LAKE DRIVE PARK AND MARINA DESIGN REVIEW

for The Town of Palm Beach, Florida

Crosswalk & Roundabout

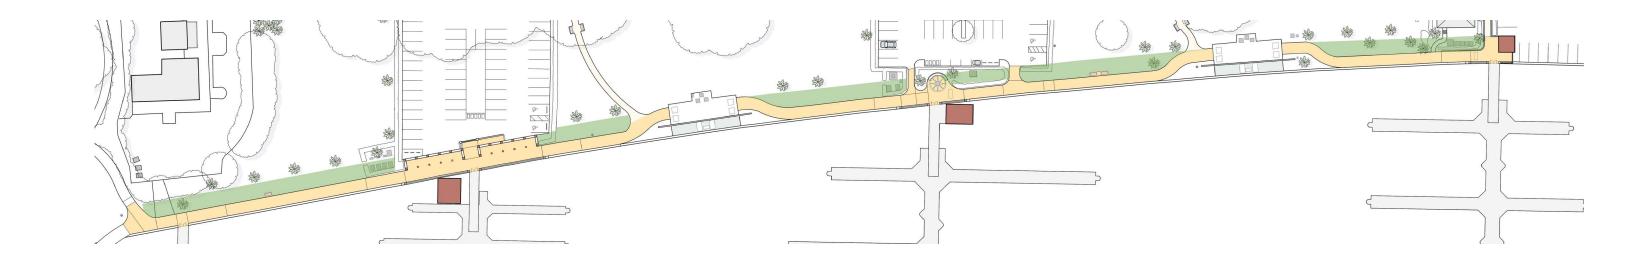
Traffic Calming Techniques

Brazilian Parking Lot Comparison

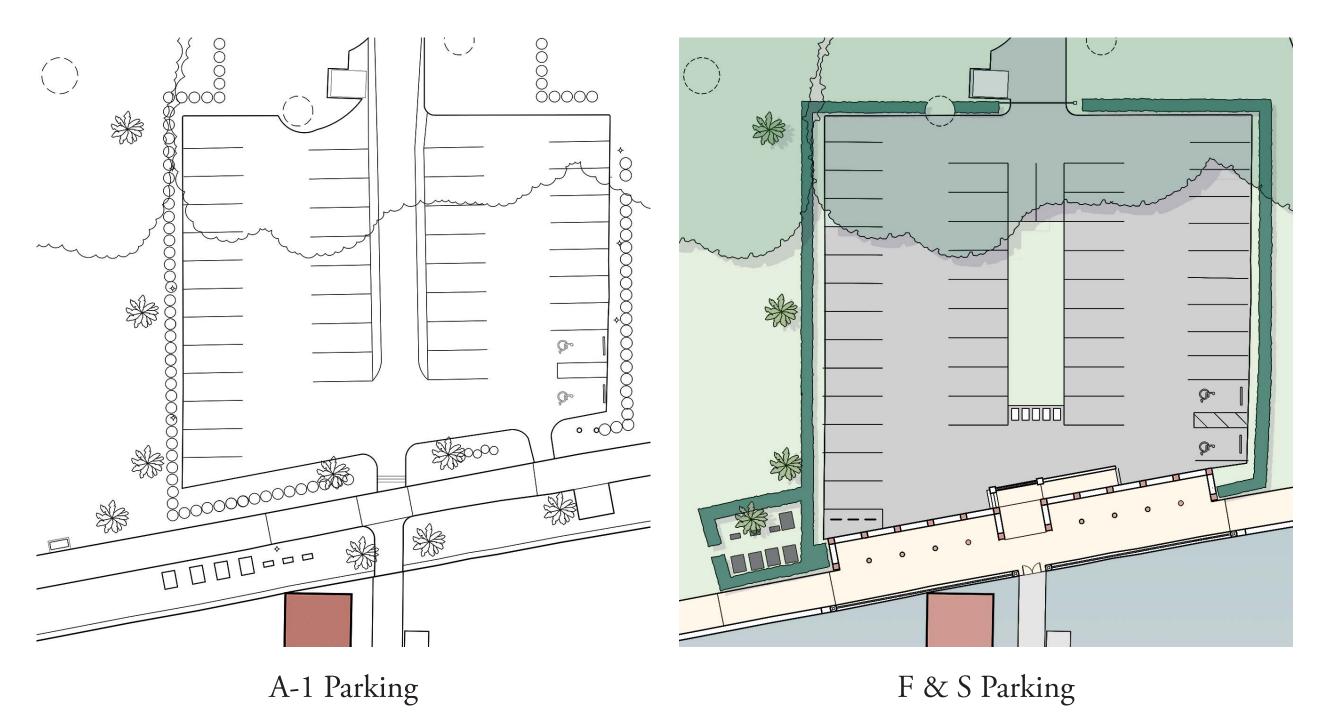
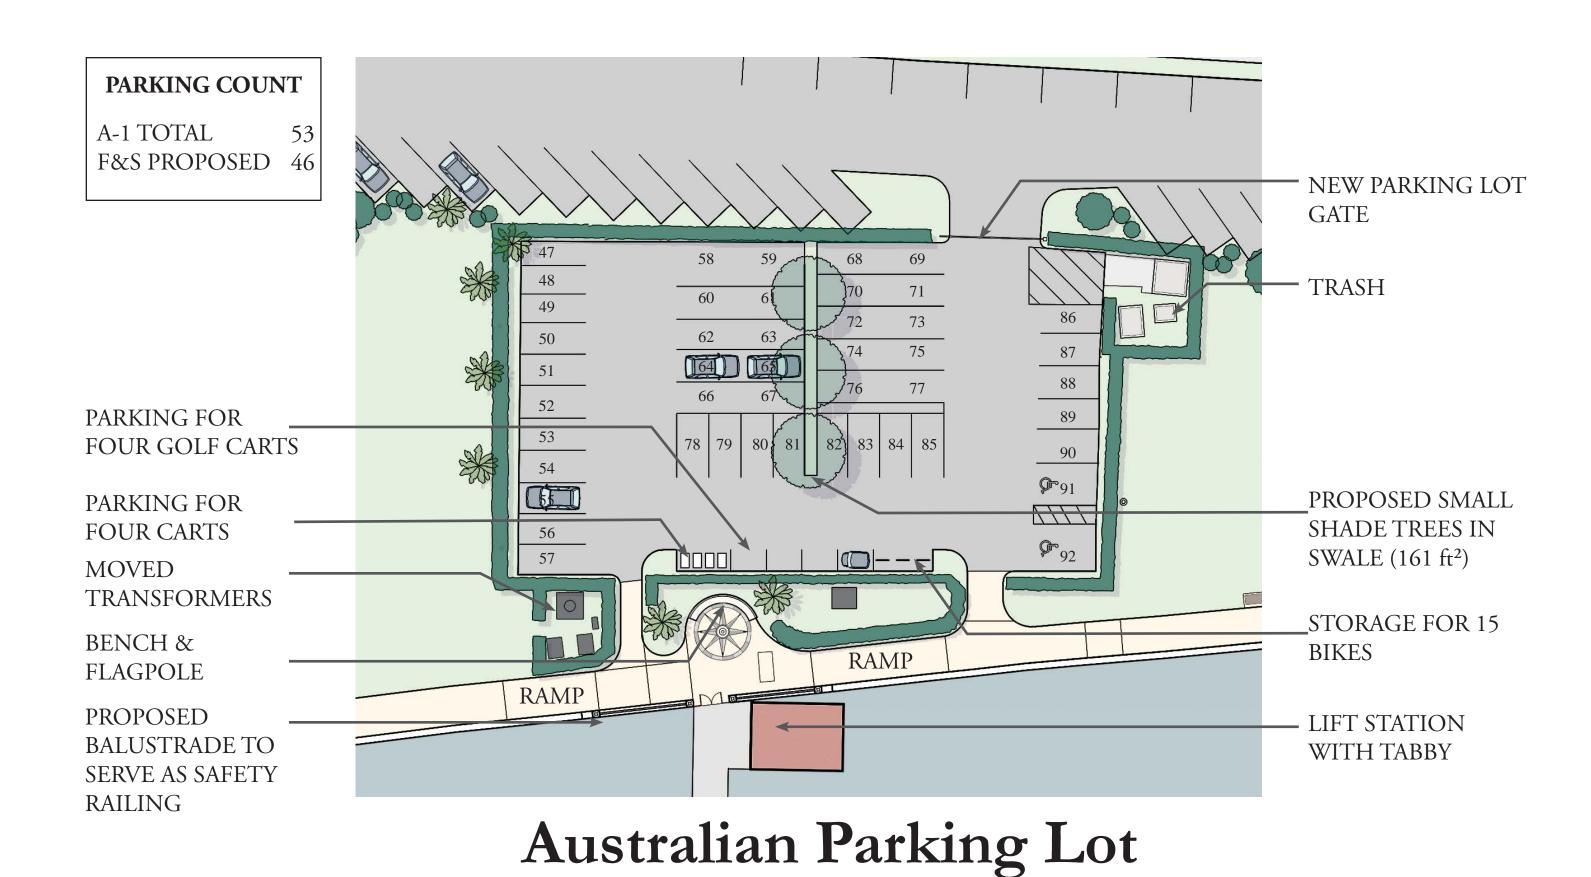
Introduce More Permeable Areas into Parking Lots

Australian Parking Lot Comparison

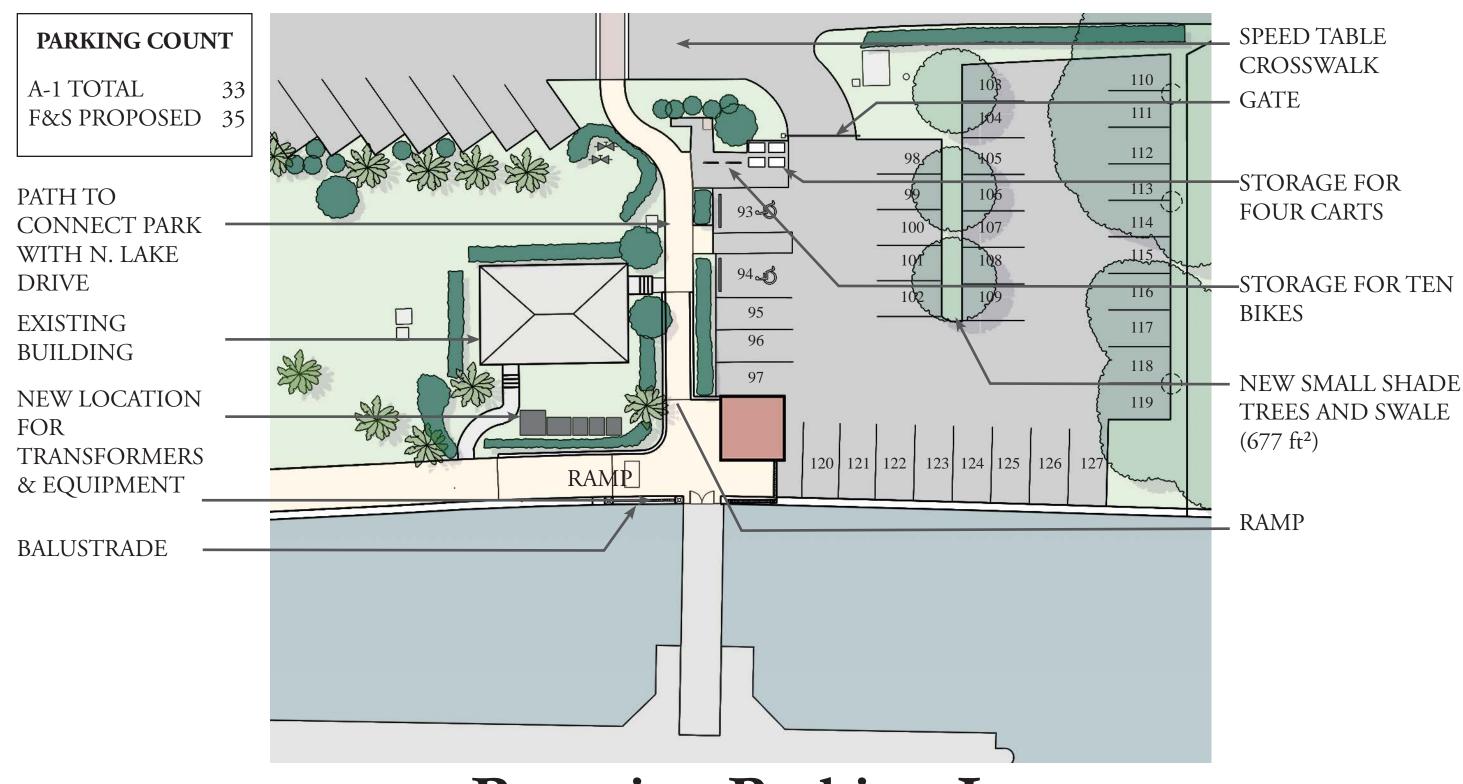
F & S Parking

Peruvian Parking Lot Comparison

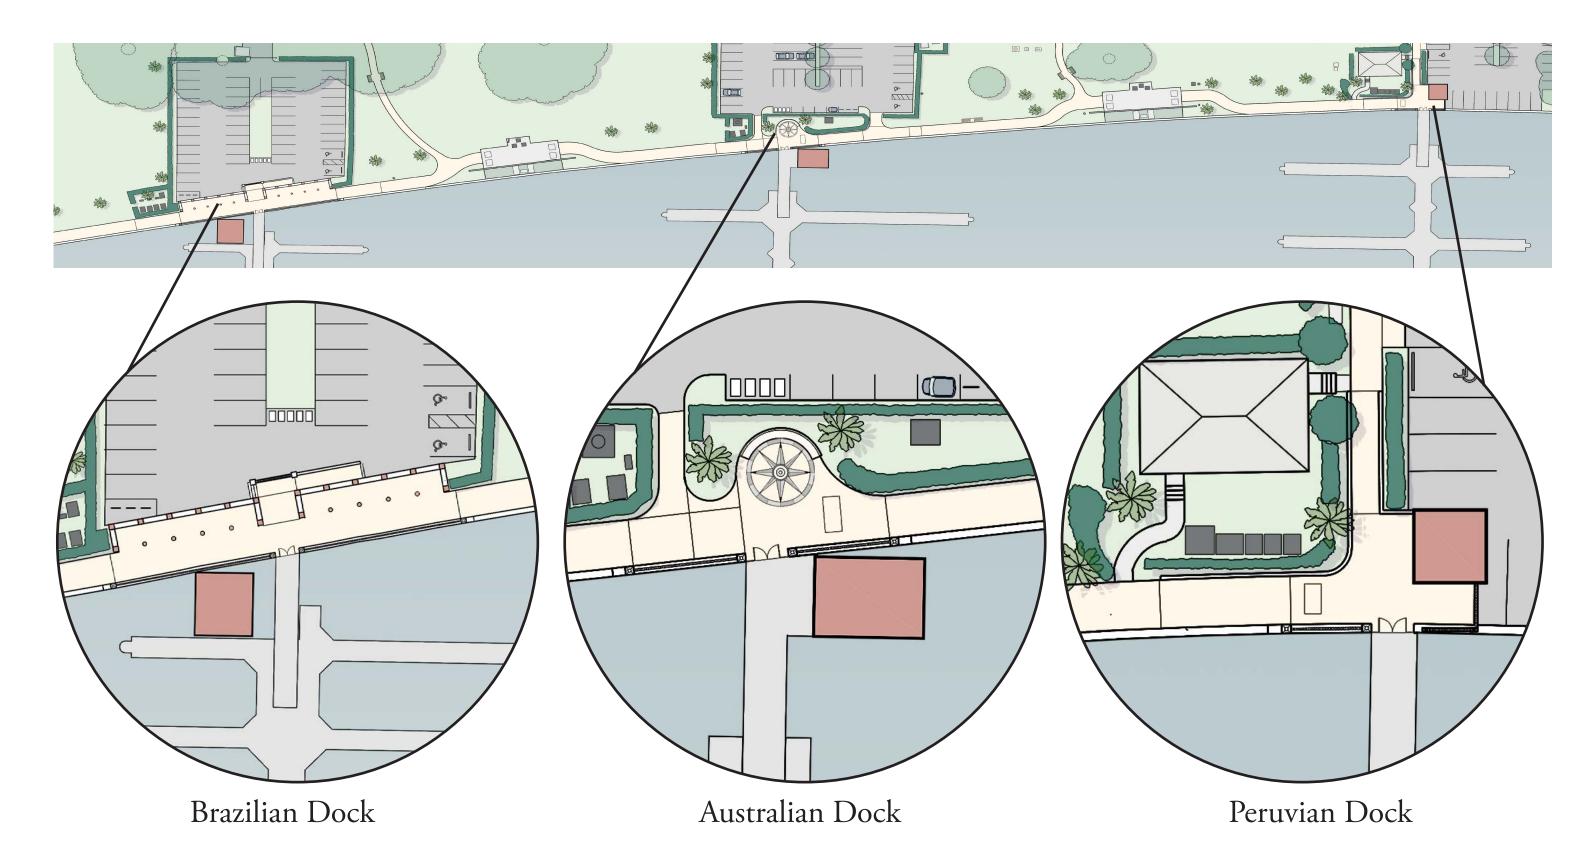
F & S Parking
